Erect garden room within garden space of house.
At 21 Braid Hills Approach Edinburgh EH10 6JZ

Application No: 19/05116/FUL

DECISION NOTICE

Report of Handling

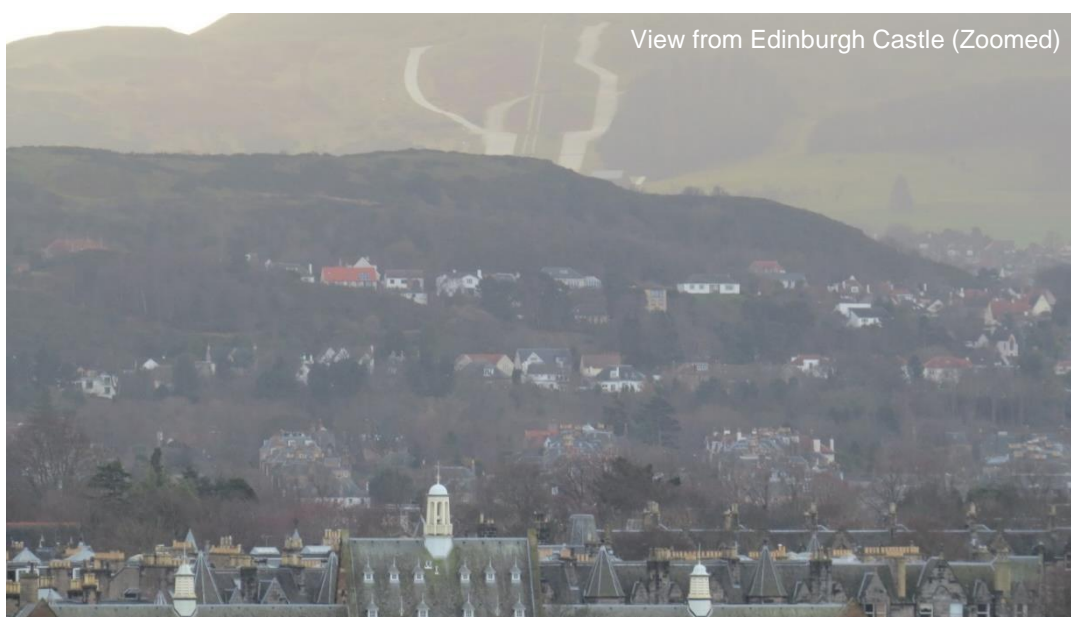
3.7 Firstly and again most importantly the proposals are to retain all trees within and out with the site so as to preserve the character and scenic value in this regard as far as possible so we ask that all references to significant adverse impact on the scenic value, quality and character of the area to this effect are dismissed and the fact that the trees retained as existing are an important element to consider the proposals against with regard to screening the development.

3.8 The secondary element to evaluate/ discuss is the planning officer’s comments that the proposals would result in a “highly visible form of development”. The planner has noted that the following views will be affected, from Buckstone Snab, Braid Hills Road, Edinburgh Castle, Corstorphine Hill, Craiglochart Hill (which

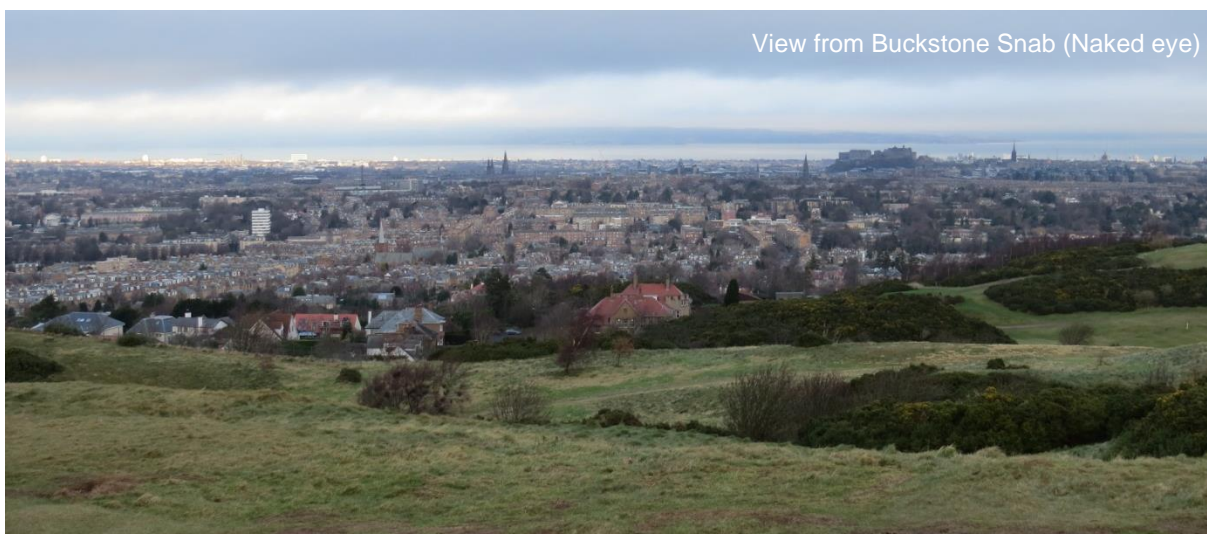
3.9 Edinburgh Castle – The planning department passed over the below photograph with regard to the view from Edinburgh Castle of the area being adversely affected. This viewpoint was also one of the few we managed to gain photos from prior to the pandemic. The red roof of the house at 21 Braid Hills Approach can partly/ slightly be seen in the left of the photo, it is largely screened by the rock outcrop and vegetation. To the right of number 21 the other more distinguishable red roof of 14 Braid Hills Approach, with its glazed balcony, can be seen along with part of number 12. The garden room is to be positioned between numbers 21 and 12 as you look at this photo however, we believe that it will be unseen or at most very minimally seen if this photo were taken upon completion. Even it was to be partly seen it would be relatable to the buildings that would form the backdrop to the garden room.

3.10 The below photo is a photo AMA have taken. The difference in the photos is that the photo received from the planning department has zoomed into the site location. On top of the aforementioned justification that the garden room will be unseen or at most slightly seen but falling into the backdrop of other buildings, when you look at the below photo as to how the site location will be seen from a human naked eye the site location is extremely hard if not impossible to distinguish without use of a zoom and guidance. As one looks towards the site, the proposals will blur/ merge into the conglomeration of the city fabric. To this we can justify that this view will not be adversely affected.
